DETAILED ACTION

In view of the appeal brief filed on October 7, 2010, PROSECUTION IS HEREBY REOPENED. Rejections are set forth below. To avoid abandonment of the application, appellant must exercise one of the following two options:

Elected Species

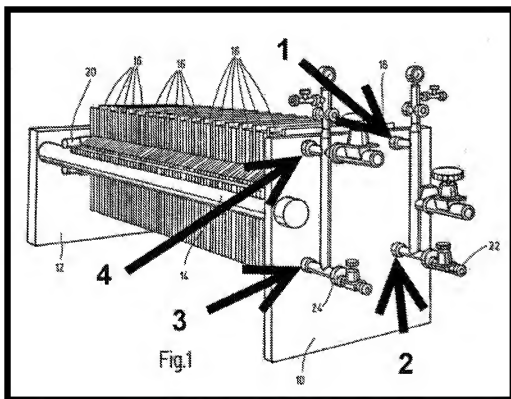
Applicant has failed to teach those skilled in the art how fluid communication between the **FOUR** unlabeled ports (see annotated Figure 1 below) in “**mounting plate**” **10** and the **EIGHT** orifices/ports (**38, 52, 56** and **36** in the top; **38, 52, 56** and **36** in the bottom) in the **frame 16** of **Figure 3a** takes place.

As depicted in **Figure 1**, **frame 16** is pressed against **"mounting plate" 10**. It is unclear from the disclosure (including and considering those supplemental portions that were added years after the initial filing) how the **EIGHT** ports/orifices of frame 16 of **Figure 3A** fluidically communicate with the **FOUR** unlabeled ports/orifices of **"mounting plate" 10** as depicted in Figure 1. The disclosure (including and considering those supplemental portions that were added years after the initial filing) fails to teach how these ports/orifices communicate with each other. For this specific technical reason, one skilled in the art would be unable practice the invention without undue experimentation.

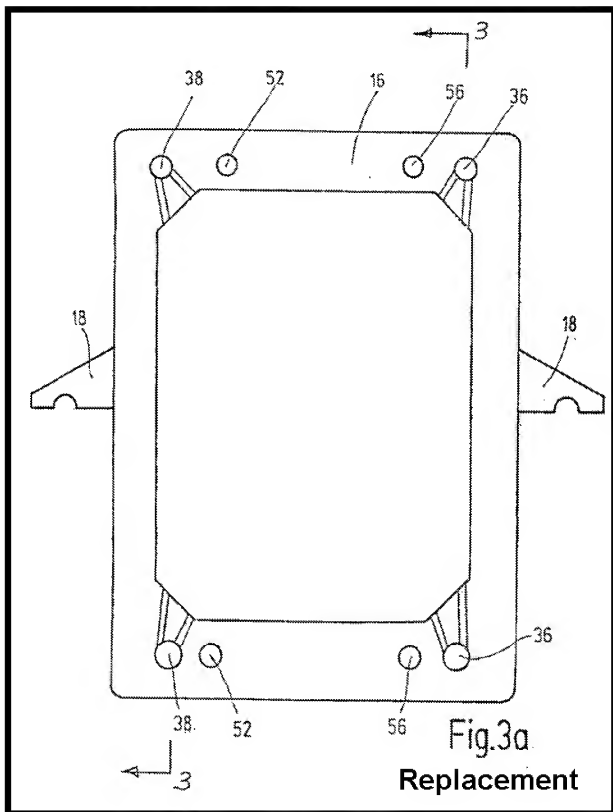
Applicant's **Figure 3** et al. depict **filter cloth 46** extending across "**input channel**" **36**, and "**filtrate channel**" **38** at numerous locations (see Replacement Fig. 3 above which has been annotated by the undersigned with eight small circles encircling the areas having filter cloth which are in question). The passage of "**unfiltered material**" across the first encountered section of "**input channel**" **36** would appear to immediately cause that section of filter cloth to blind, or become blocked, given that it is so small in cross-sectional area and would be subject to immediate, enormous accumulation. It is unclear how other sections of filter cloth 46 would see, or be the recipient of any "**unfiltered material.**" Based on the instant disclosure, one skilled in the art would not know what structure enables the flows depicted by arrows "**f.**" It is unclear why the filter cloth is at any of the encircled locations. The disclosure (including and considering those supplemental portions that were added years after the initial filing) fails to teach why filter cloth is at the locations encircled in **Figure 3** above. For this specific technical reason, one skilled in the art would be unable practice the invention without undue experimentation.

Given the instant disclosure, one skilled in the art would not know across, and then back across the same filter 32, takes place, as the structure/means to facilitate such flow has not been clearly depicted or described. No such flow takes place in the elected species depicted in Fig. 3.

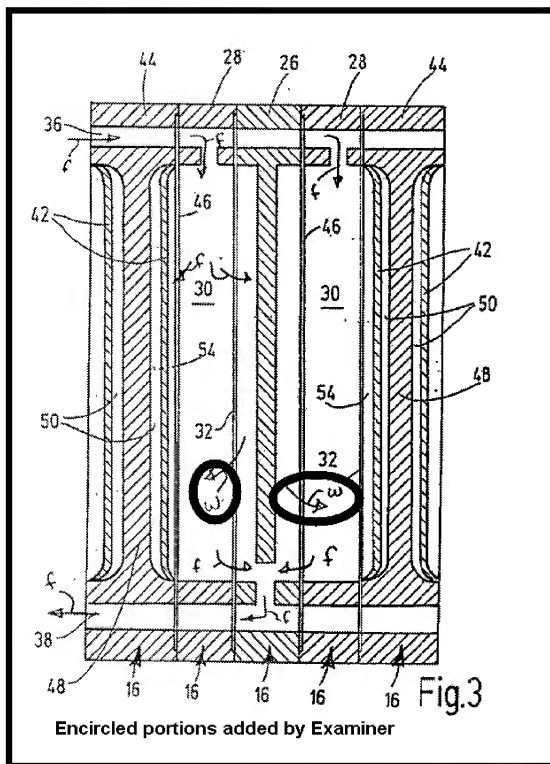
Looking to the replacement drawings submitted on **January 21, 2010**, where labels “**w**” have been added to aid in the understanding of the invention by depicting the “**washing flow**” (Remarks of January 21, 2010; Page 8; lines 8-10), it remains unclear how the wash fluid communicates with the claimed “**output,**” as the arrowhead associated with each added “**w**” ends in a chamber with no apparent outlets at all.

Moreover, it is unclear how the “**washing flow**” emanates from a chamber depicting no inlets.

It is unclear how this “**sequential**” washing flow takes place. Looking to the replacement drawings submitted on **January 21, 2010**, where labels “**w**” have been added to aid in the understanding of the invention by depicting the “**washing flow**” (Remarks of January 21, 2010; Page 8; lines 8-10), it is not clear that claim 8 even reads on the elected species, that being depicted in Figure 3 and 3a. The “**washing flow**” “**w**” as depicted in Replacement Figure 3 depicts non-sequential split-flow passage across media 32 (laminar filter) and 46 (filter cloth). Beyond that, it is unclear where the “**washing flow**” “**w**” as depicted in Replacement Figure 3 flows. In any event, clearly, the “**washing flow**” “**w**” as depicted in replacement Figure 3 does not show “**feeding a washing fluid sequentially through each set of the second filter mediums, the filter cakes and the laminar filters in that order.**” Following “**w**” to the left, it flows first through a laminar filter 32, and thereafter, to who knows where, but it flows first through a laminar filter. Following “**w**” to the right, it flows first through filter cloth 46, and thereafter, to who knows where, but not “**sequentially through each set of the second filter mediums, the filter cakes and the laminar filters in that order.**”

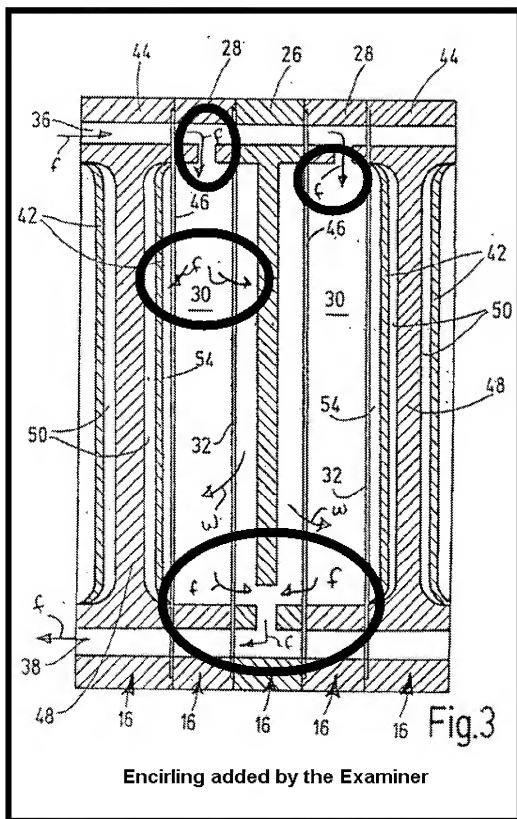
It is noted here that the **“washing flow”** arrows **“w”** depicted in replacement Fig 3 above, appear to be in complete disagreement with what is taught in the specification:

Independent claims **8** and **14**, the only two presently pending independent claims, specify **“discharging filtrate through an output,”** and **“an output for discharging filtrate,”** respectively. It is unclear how filtrate arrives at the **“output.”** Referencing the replacement drawings submitted on **January 21, 2010**, where labels **“f”** have been added to aid in the understanding of the invention by depicting the **“filtering flow”** (Remarks of January 21, 2010; page 8; lines 8-10), it remains unclear how filtrate arrives at the claimed **“output.”** Replacement Fig. 3 depicts nonsequential flow across both filter cloth 46 and laminar filter 32. It is unclear how **“filtering flow”** which passes across filter medium 46 which is adjacent membrane (the third encircled portion from the top of the annotated Fig 3 immediately above) exits pressure chamber 54.

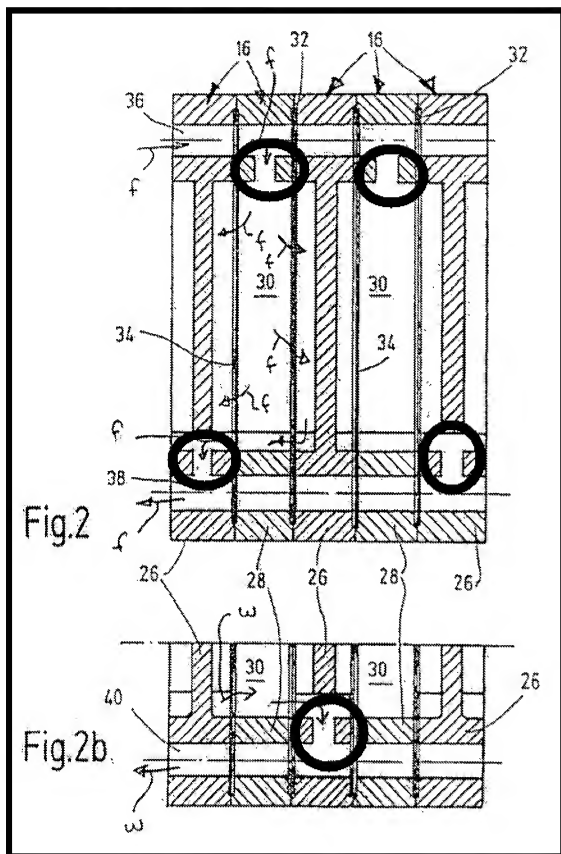
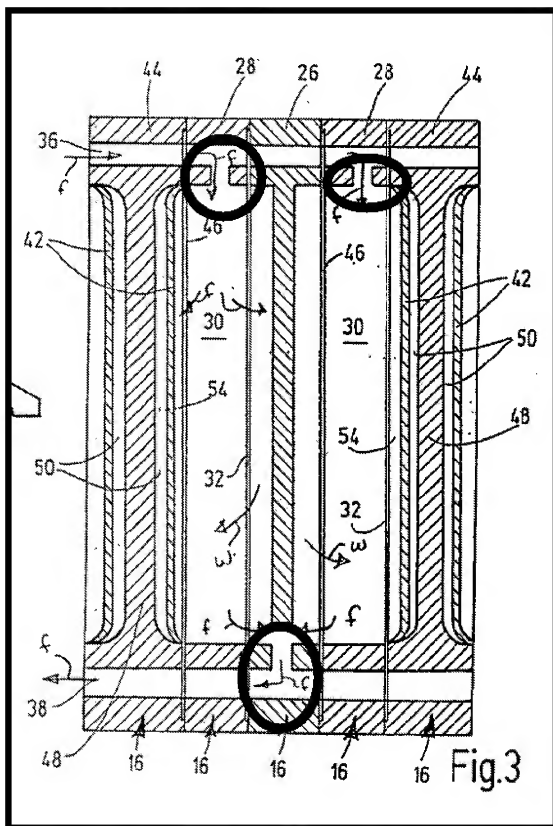
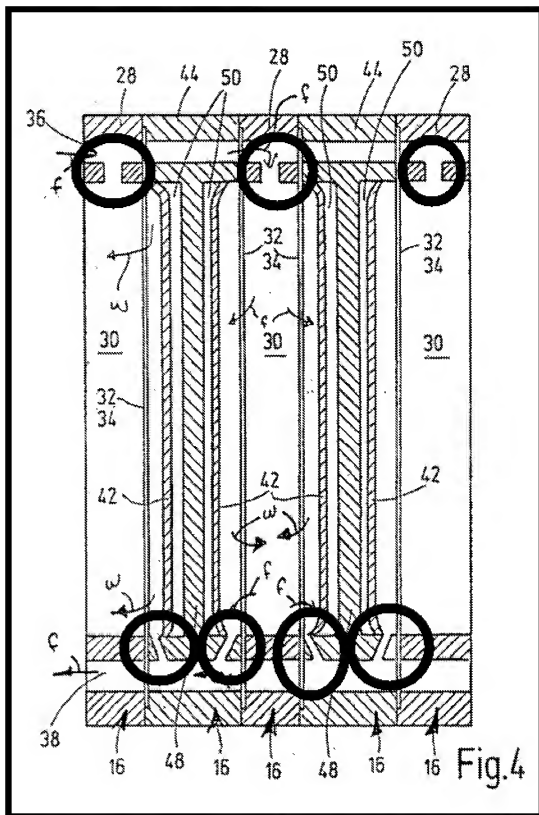
The drawings are objected to because it is **unclear what the unlabeled structure in Fig 3a (elected) et al is, or where it is described in the originally filed specification.** Reference is made to the annotated version of Replacement Fig. 3a below:

The same questions arise with respect to similar structure in **Fig. 2a** and **Fig. 4a**.

Additionally, it is unclear what specific frame parts "**16**" are identified in each of Figures **2a**, **3a** and **4a**. It is unclear why each of Figures **2a**, **3a** and **4a** contains reference numeral "**16**" without an "**arrowhead**" (see Remarks of 1/21/10 page 8; lines 13-16), especially, since no "**sets**" are depicted in these figures.

It is unclear what passages are depicted in the following annotated drawings, where they are described in the specification, or why they are unlabeled. They have been encircled to facilitate analysis:

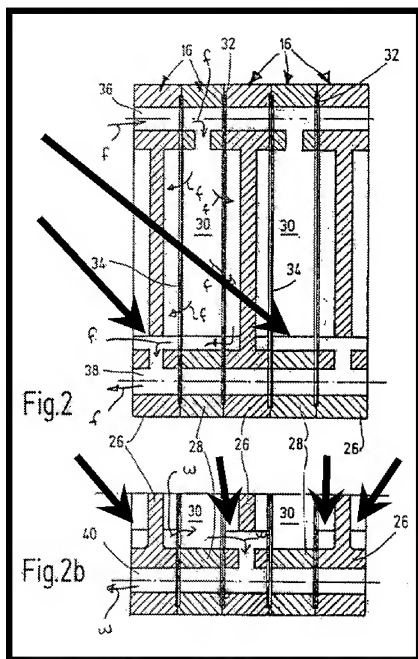
It is unclear what the lines (see annotating arrows) in Replacement Figures 2 and 2b indicate or mean, and, where they are described in the specification. It is unclear why similar lines do not appear in Figures 3 and 4.

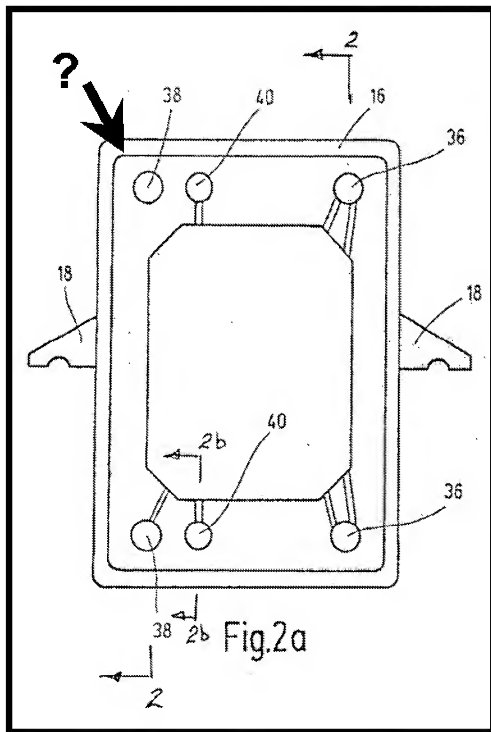
It is unclear what the **perimeter line** (see annotated drawing below) in Figure 2a denotes, or why such a line is not present in Figs 3a or 4a?
